Interactive comment on “A novel method for cold region streamflow hydrograph separation using GRACE satellite observations” by Shusen Wang et al.

Shusen Wang et al.

Received and published: 25 February 2021

Figure RC1-1: Solutions for k_0 , T_c , and a using NSE as the criteria. Ranges of parameter values:
 $0.006 < k_0 < 0.009$, $430 < T_c < 770$, $36 < a < 55$.

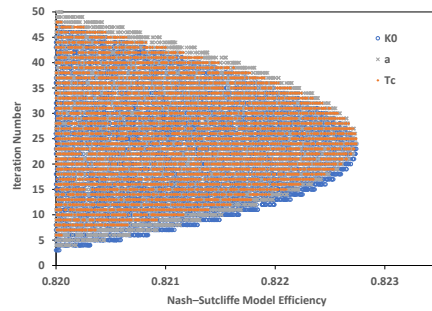
2. The manuscript is revised by adding details for the parameter estimation. The numerical scheme for this study, coded in FORTRAN, will be made available to the public through the Canada Centre for Remote Sensing Open Data Portal. The program includes a triple-nested numerical iteration for the three parameters of k_0 , T_c , and a . We used an iteration of 50 for each parameter with its given range of values. So, the total parameter combinations for a numerical experiment is 50^3 . This takes about 10 CPU-minutes for a regular desktop computer. The initial values for the parameters can be estimated from either available information or expert knowledge. In this study, the values obtained in Wang (2019) were referenced. Prior numerical experiments with relatively large ranges and coarse resolutions for the parameter values could be helpful to narrow down the final ranges. The solution with maximum Nash-Sutcliffe Efficiency corresponds to a unique combination of k_0 , T_c , and a , and the solutions with a range of top Nash-Sutcliffe Efficiency values include a large number of combinations of k_0 , T_c , and a . This can be seen from the Figure RC1-1 attached. Numerically, it reflects the interactions of parameters in the baseflow simulations (e.g, low a compensates low k_0). Physically, it suggests the level of accuracy for parameters with the prescribed accuracy of Nash-Sutcliffe Efficiency. As such, the large number of parameter combinations is an over exaggeration, as many of them are under the prescribed accuracy level.
